DART SERVICE INSTRUCTION

TO AMEND INSTALLATION INSTRUCTIONS D205-541 REV. J AND
INSTRUCTIONS FOR CONTINUED AIRWORTHINESS ICA-D205-541 REV. 4

REF TCCA STC: SH96-120

DESIGN	DW	DART AEROSPACE LTD HAWKESBURY, ONTARIO, CANADA	
DRAWN	DW		
CHECKED	AP	DRAWING NO.	REV. A
MFG. APPR.	N/A	DSI 9667	SHEET 2 OF 2
APPROVED	<i>[Signature]</i>	TITLE	SCALE
DE APPR.		WASHER ADDITION	NTS
DATE	14.11.27	COPYRIGHT © 2014 BY DART AEROSPACE LTD THIS DOCUMENT IS PRIVATE AND CONFIDENTIAL AND IS SUPPLIED ON THE EXPRESS CONDITION THAT IT IS NOT TO BE USED FOR ANY PURPOSE OR COPIED OR COMMUNICATED TO ANY OTHER PERSON WITHOUT WRITTEN PERMISSION FROM DART AEROSPACE LTD.

FIGURE 1

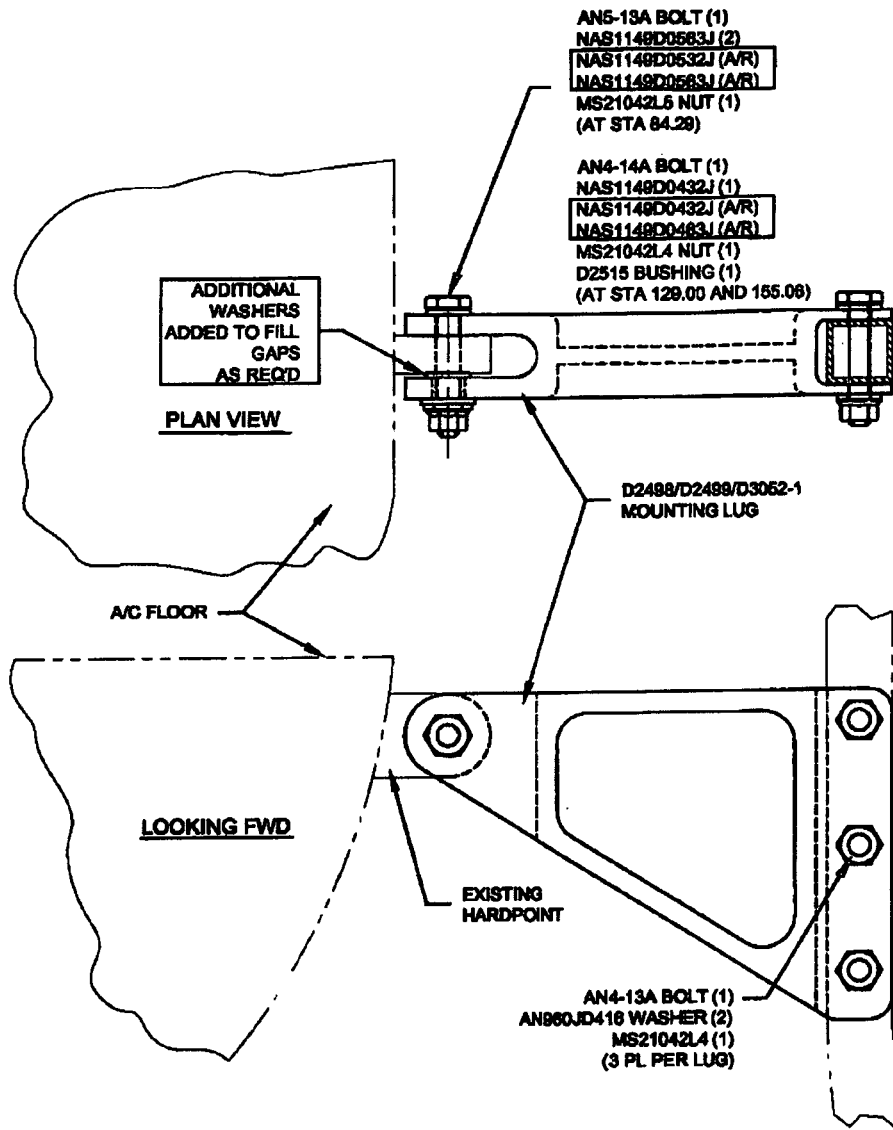
FOR CUSTOMERS/OPERATORS CONCERNED WITH GAPS AT STA's 84.29, 129.00 AND 155.06 WHILE INSTALLING D205-541-043/-044/-045/-046 BASKETS, IT IS ACCEPTABLE TO FILL THE GAPS WITH WASHERS TO REDUCE UNNECESSARY STRESS ON THE MOUNTING LUGS.

INSTALL THE D205-541-043/-044/-045/-046 BASKET KITS PER INSTALLATION INSTRUCTIONS D205-541 WITH ADDITIONAL WASHERS AS SHOWN IN FIGURE 1 OF THIS SERVICE INSTRUCTION.

4	4	4	4	NAS1149D0463J	WASHER
4	4	4	4	NAS1149D0432J	WASHER
2	2	2	2	NAS1149D0532J	WASHER
2	2	2	2	NAS1149D0563J	WASHER
